Gatwick Airport Northern Runway Project

Response to the ExA's Proposed Schedule of Changes to the Draft DCO

Application Document Ref: 10.72

Figure 2.3 ICAO Global Trends In Aircraft Noise 2022 Figure 10.1

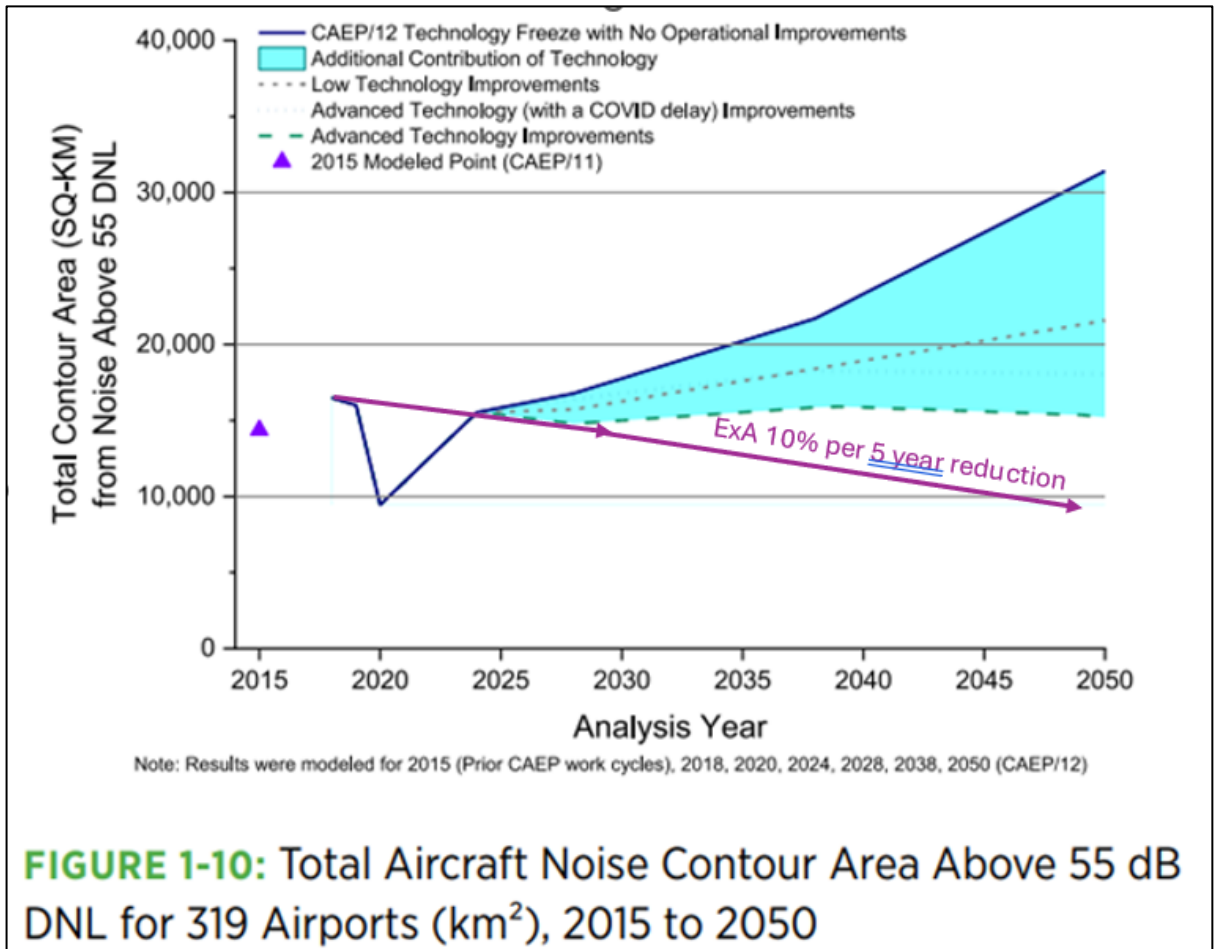
- 2.2.13 Firstly, Figure 1.10 of the ICAO report shows Leq noise contour areas increasing, not decreasing. This figure is reproduced below showing the (day night level) noise contour area of the composite 319 airports growing under the various technology scenarios ICAO considered. On top of this in purple has been added the ExA's proposal to reduce contour areas by 10% from 1019 to 2029 and by a

Figure 2.4 Leq 16 hr 51dB Contour Areas and the ExA Proposed Noise Envelope Limits

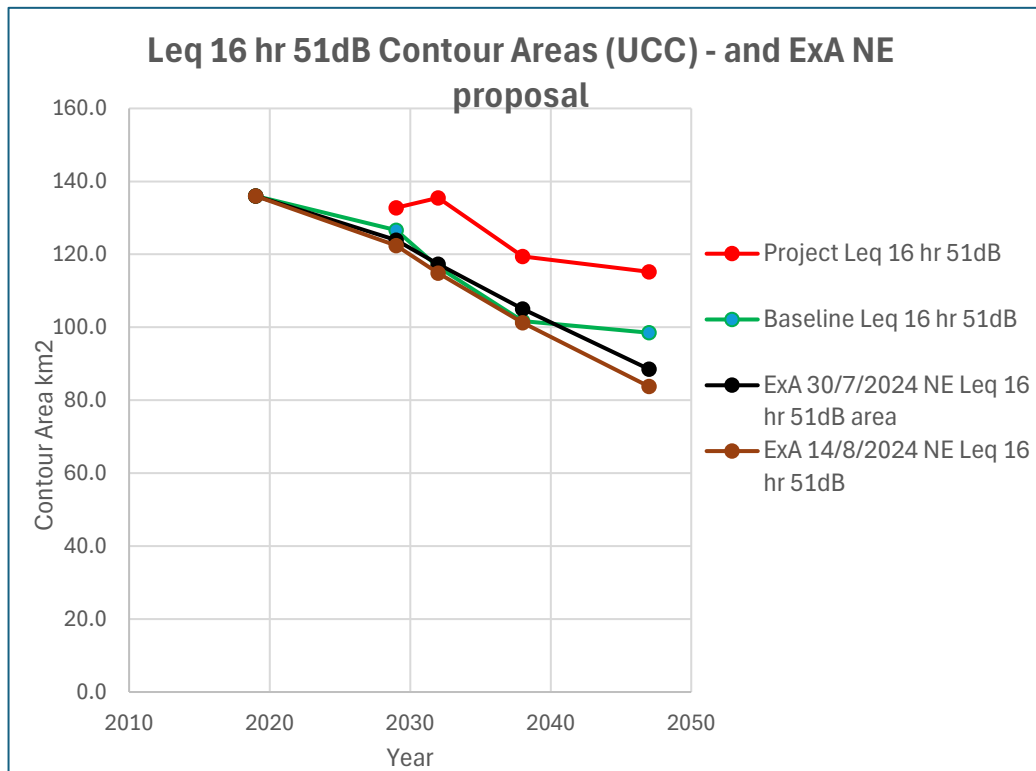
Updated Central Case Aircraft Fleet Report [[REP4-004](#)] updated in [REP8-012]). The two figures below show the predicted Leq 16 hr 51dB and Leq 8 hr night 45dB contour areas along with the corresponding two sets of noise envelope limit proposed by the ExA. The ExA proposed limits have been interpolated linearly between the 5 yearly 10% reductions from 2029 to 2047, to give the limits in the modelled years 2029, 2032, 2038 and 2047.

2.2.22 Clearly, the noise reductions proposed by the ExA's (latest) proposed noise limits will not be met without large scale reductions in planned activity at Gatwick. This is the case in various future baseline years as well as in all years with the Project's forecast air traffic added. To guarantee to stay within the proposed noise limits would require a reduction in existing flight numbers at Gatwick below 2019 levels, which would make any expansion project impossible. The airport would have to progressively reduce the number of flights rather than increasing them.
